ORDER—dated 18th September 1884, No. 2299 W., Public Works.

The estimate, amounting to Rs. 564, for fixing lightning conductors for the native infantry magazine at Cannanore, in the Malabar district, is sanctioned.

Native Infantry Magazine at
Cannanore

NOTE OF REMARKS.

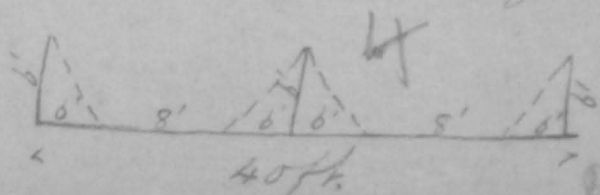
1. The accompanying estimate provides for attaching lightning conductors to the Native Infantry Magazine at Cannanore, and it amounts to Rs. 564. The sketch of the Magazine submitted is not sufficiently accurate to accept as a guide for measurements.
2. The terminals, each 8 ft. high, are placed one at either extremity, and one at the center of the ridge. Now from the estimate it may be learnt that the length of the ridge is 40 feet, so that there are 16 ft. of the Magazine unprotected in length.

3 terminals would suffice, if they were made 7 ft. & the two extreme ones shifted in 7 ft. towards center. However, S. G. has passed the details, & we must not interfere. I believe myself the 3 6 ft. terminals designed within the ridge & ear-banks will practically suffice.

This arrangement is not according to the letter of the ruling on the subject — though possibly safe.

3. Subject to approval, as the other details are correct, it would be well, if it be desired to have terminals at the ends of the ridge, to provide 5 terminals, each 5 feet high, as this would afford protection to longitudinal and cross sections, vertical and oblique, of the Magazine —

The breadth of building is 19 ft, so the rise of roof may be taken as 6 ft which with terminal, 5 ft, gives a height of 11 ft above top of walls.
